**TOMBALL INDEPENDENT SCHOOL DISTRICT
RFP-CSP #1004-26 – TOMBALL CREEKSIDE PARK JH AND TOMBALL MEMORIAL HS
ATHLETIC IMPROVEMENTS**

Addendum No. 06

October 13, 2026

6.4 MECHANICAL, ELECTRICAL AND PLUMBING ADDENDUM ITEMS

Item 18 Sheet E5.02A – ELECTRICAL PANEL SCHEDULES - CREEKSIDE PARK JHS

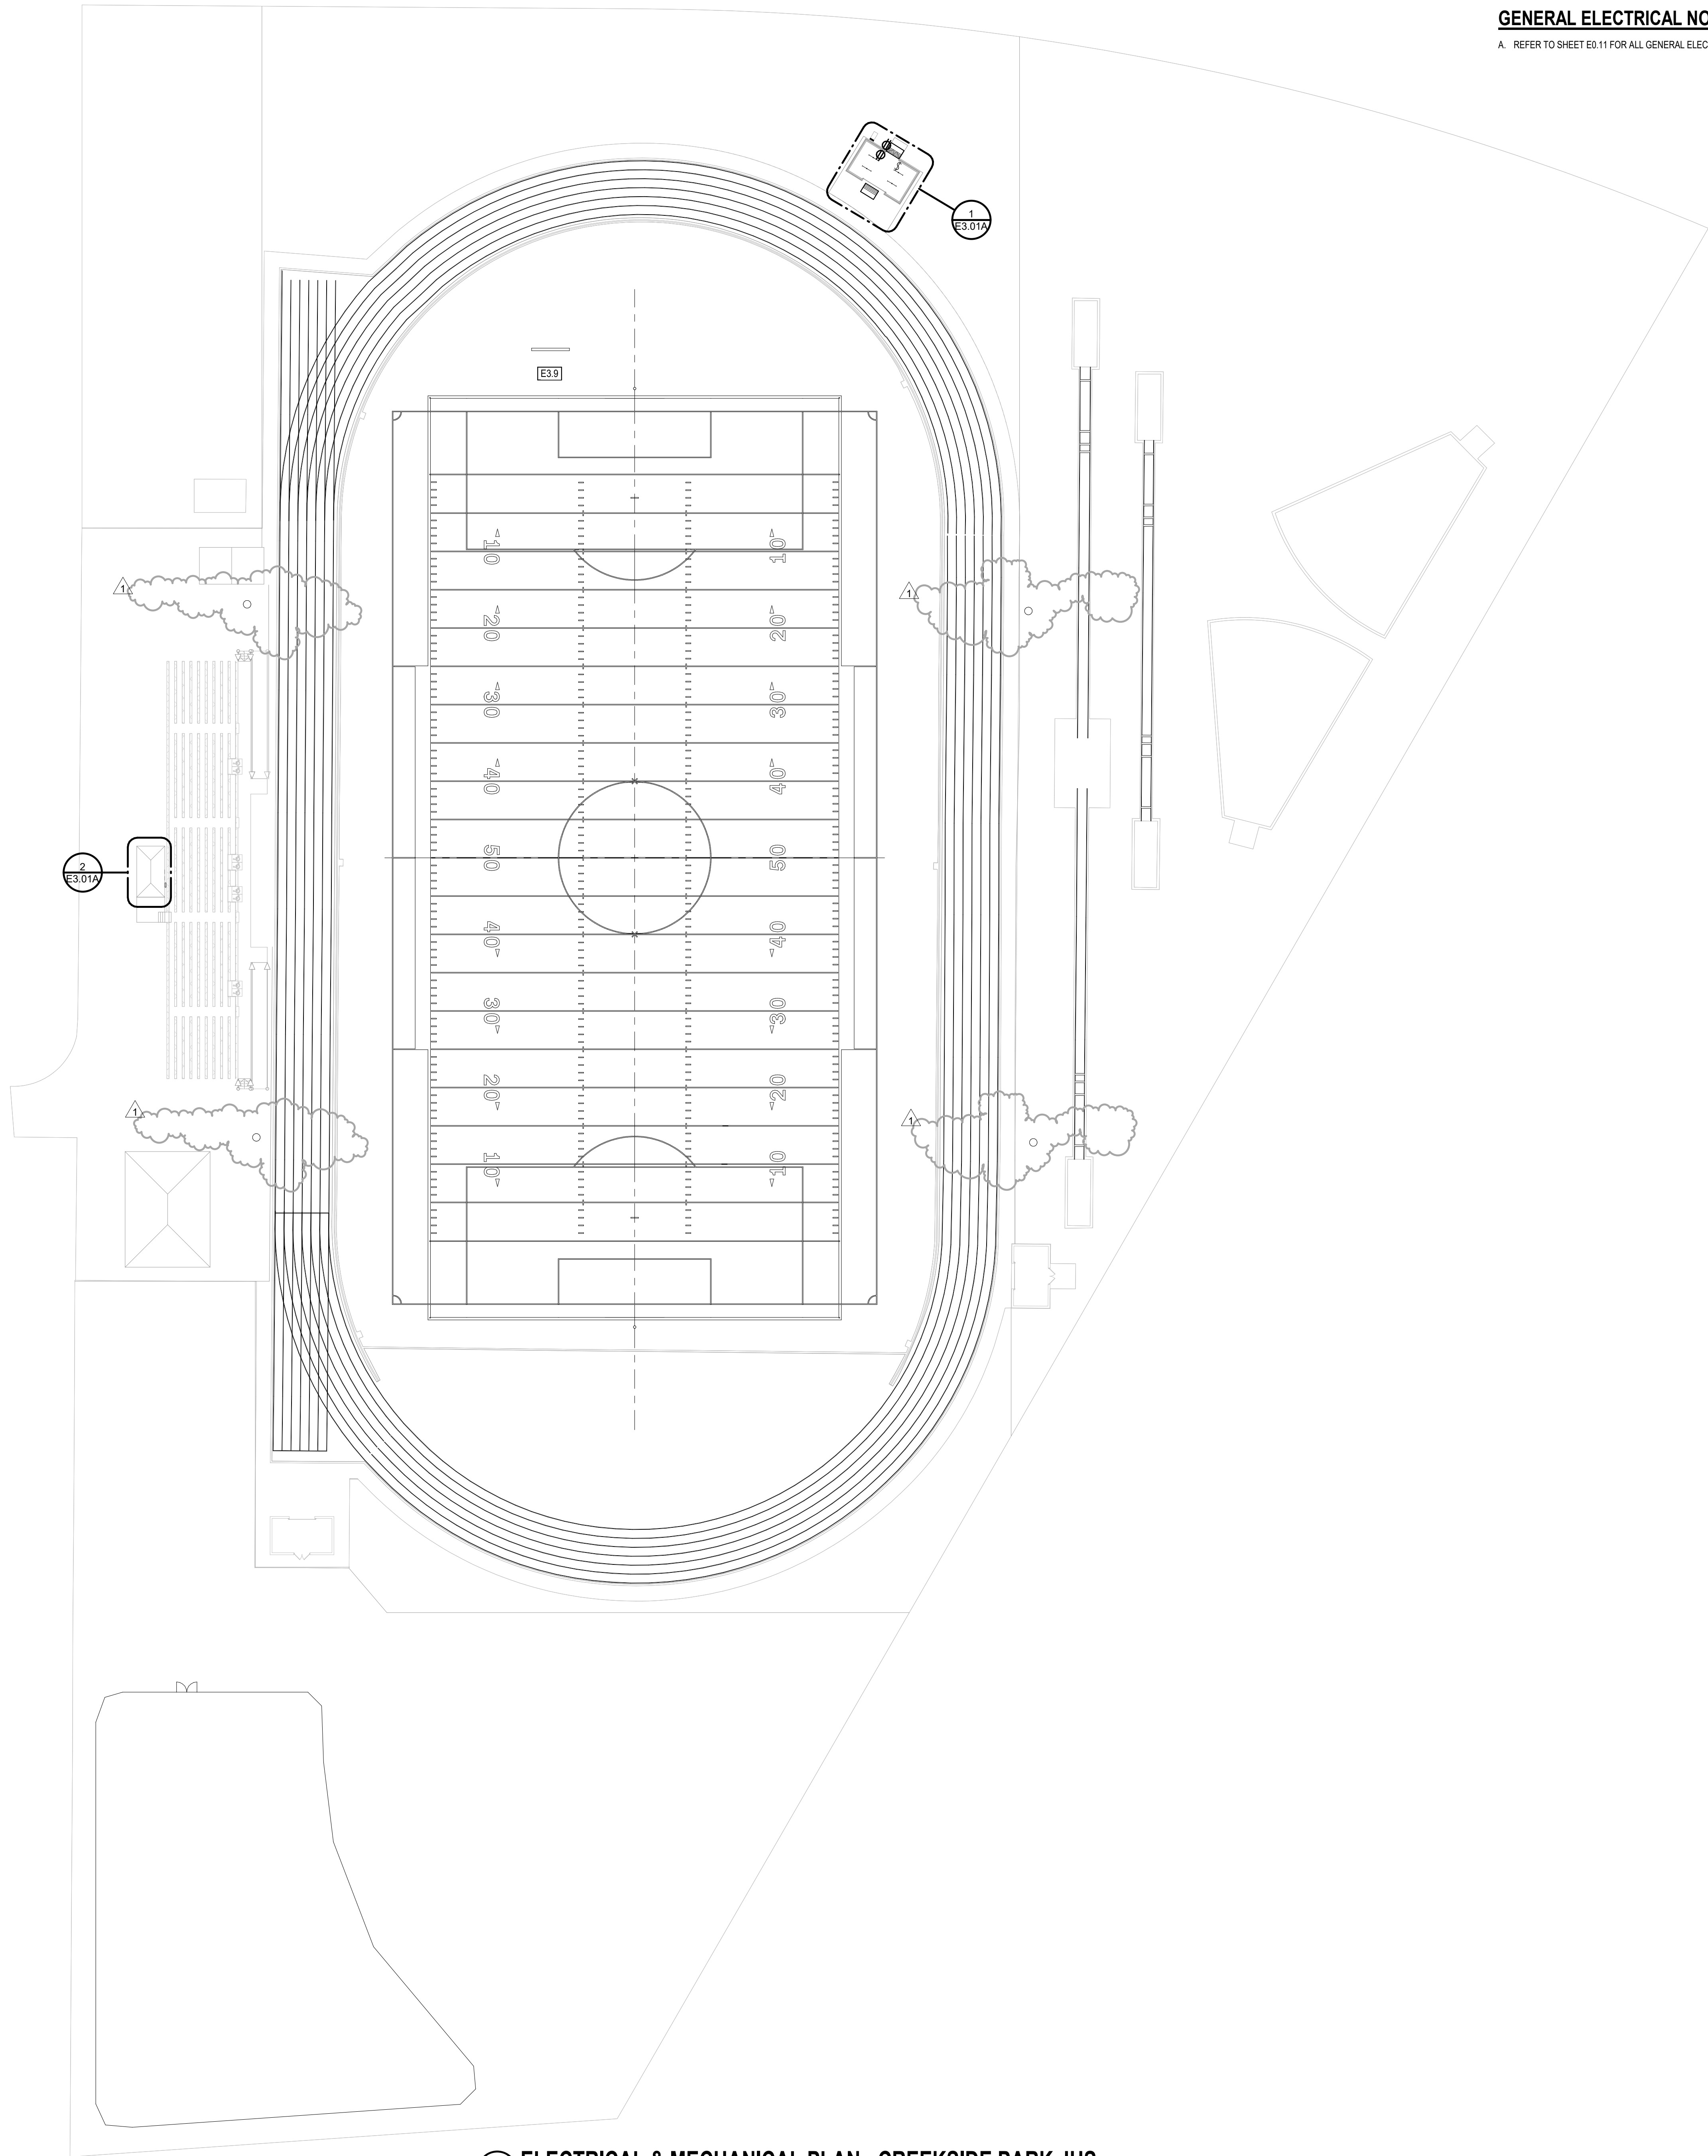
- E. Revised two (2) 30A breakers in panel DPFB to six (6) spaces.

Item 19 Sheet E5.02D – ELECTRICAL PANEL SCHEDULES - TOMBALL MEMORIAL HS

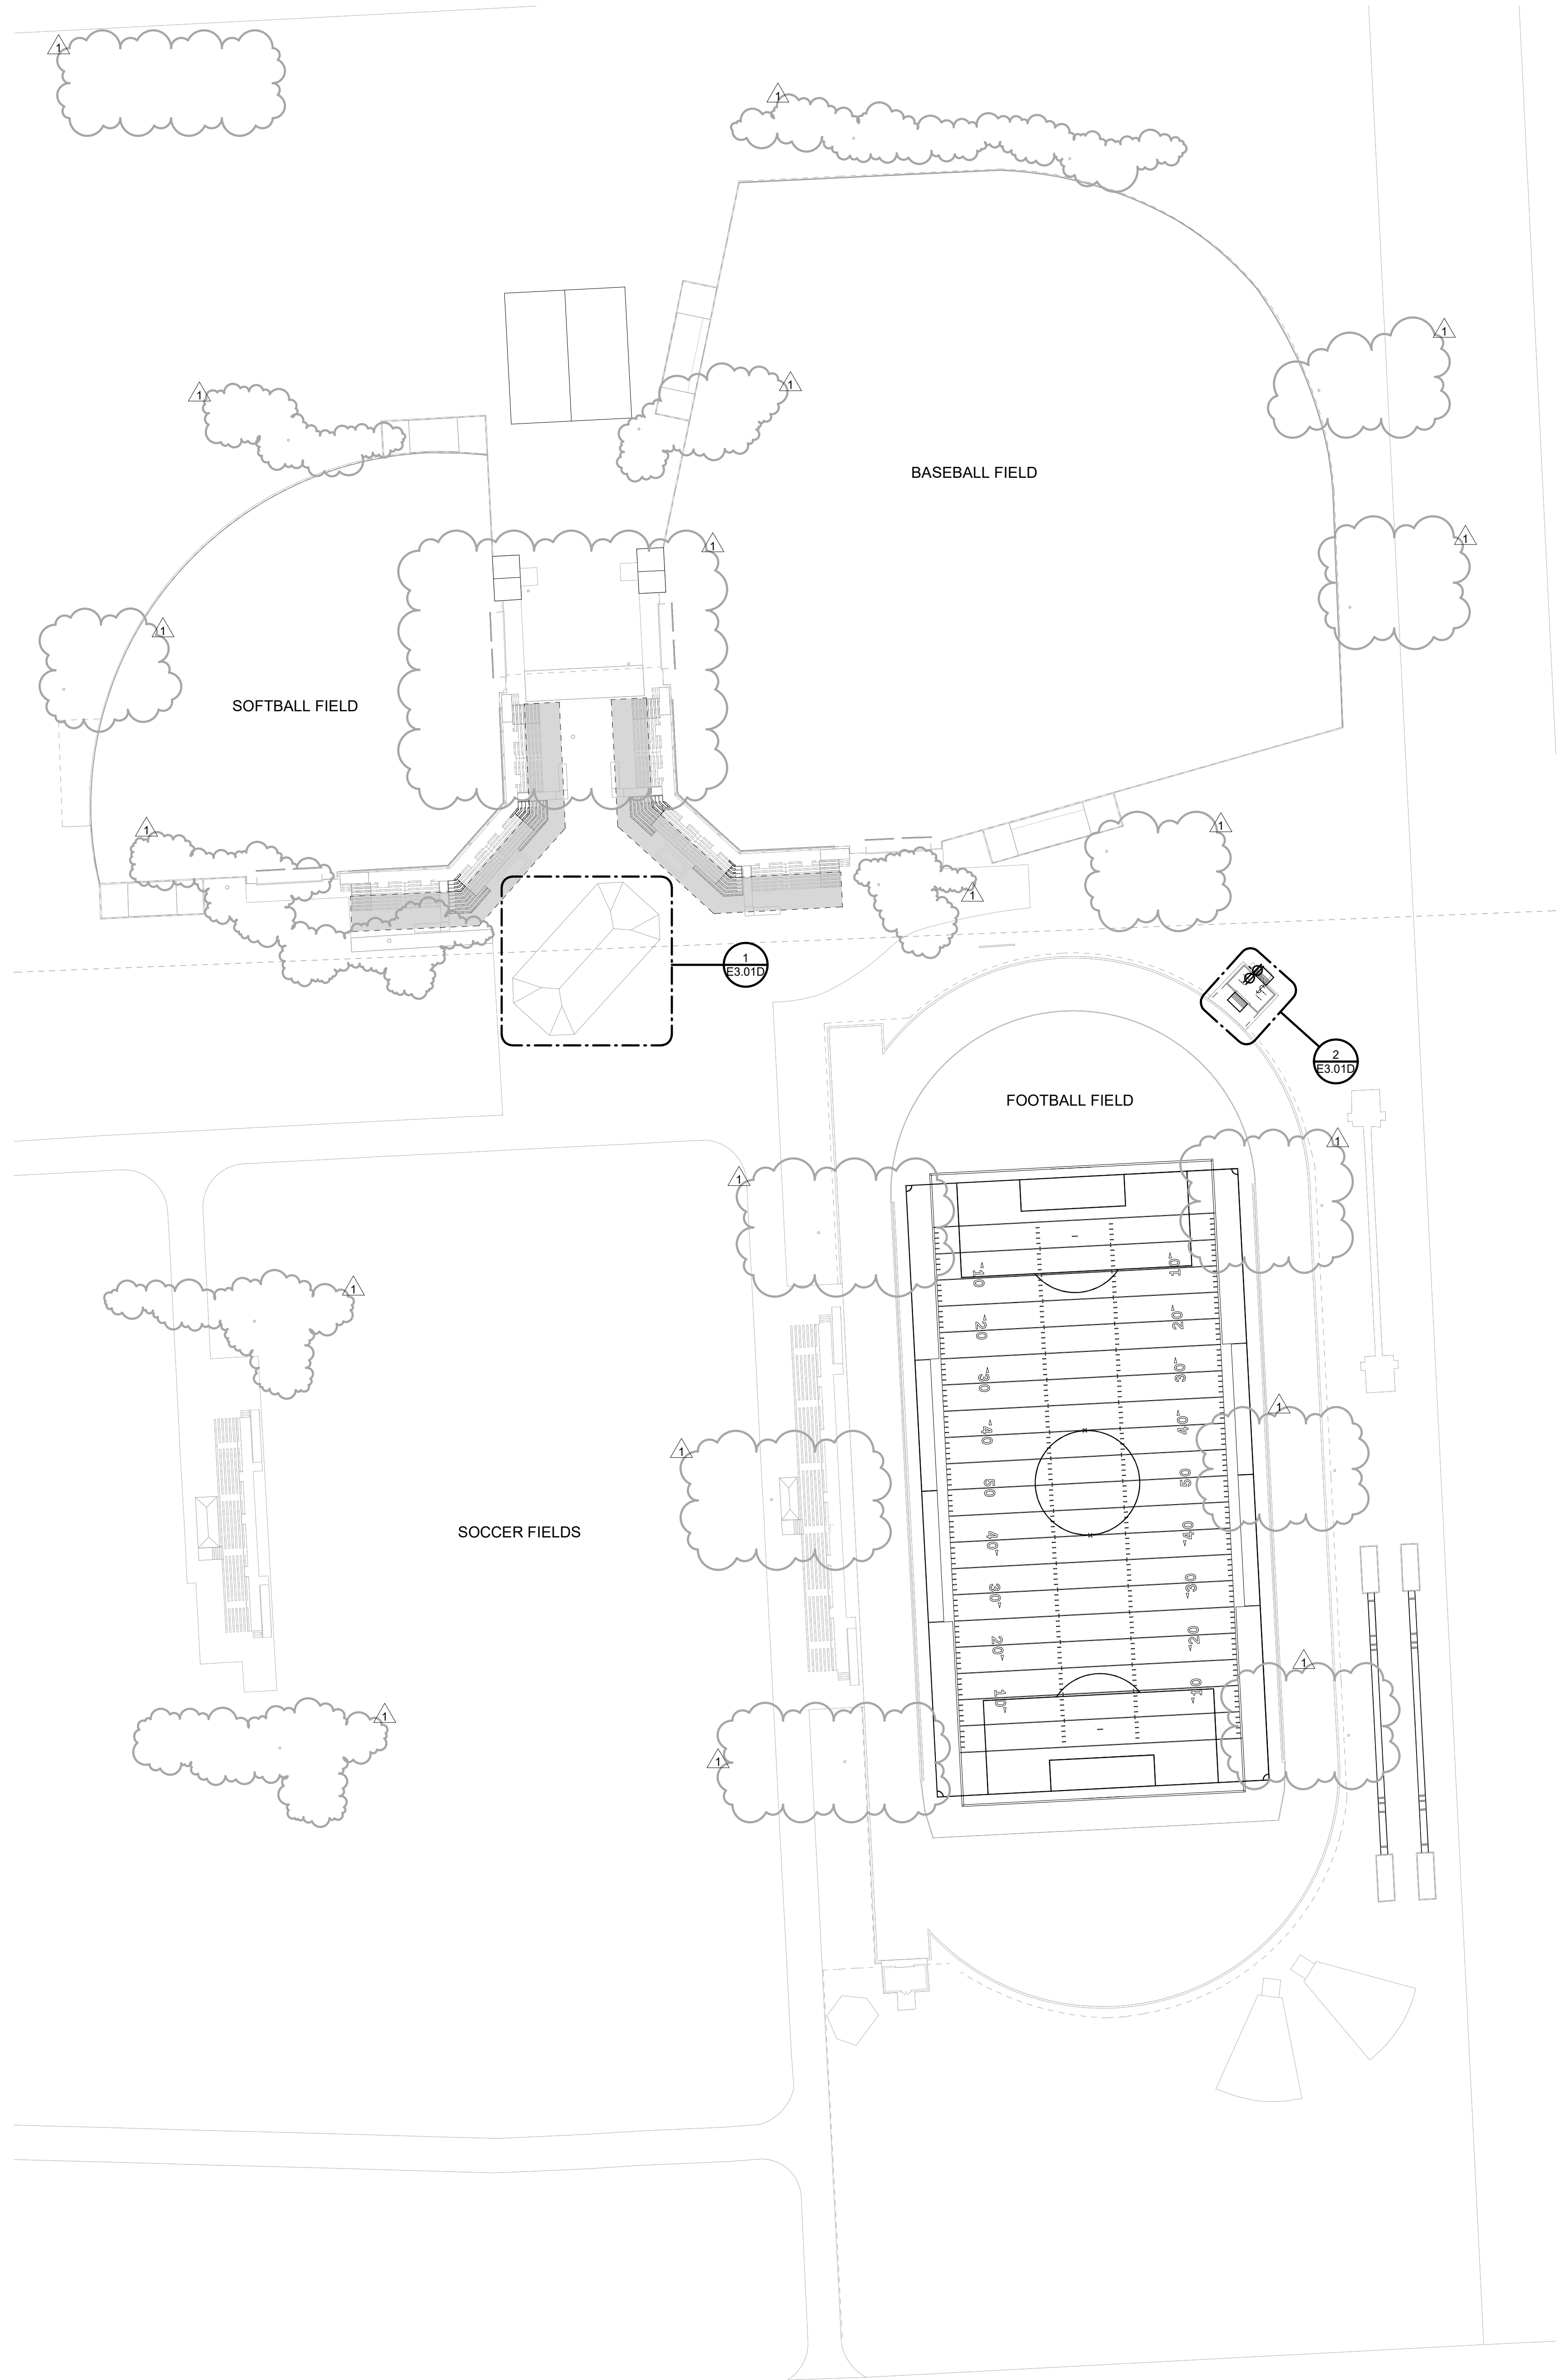
- A. Revised one (1) 30A breaker in panel 1CSH to three (3) spares.
- B. Revised two (2) 30A breakers in panel AF1 to six (6) spaces.
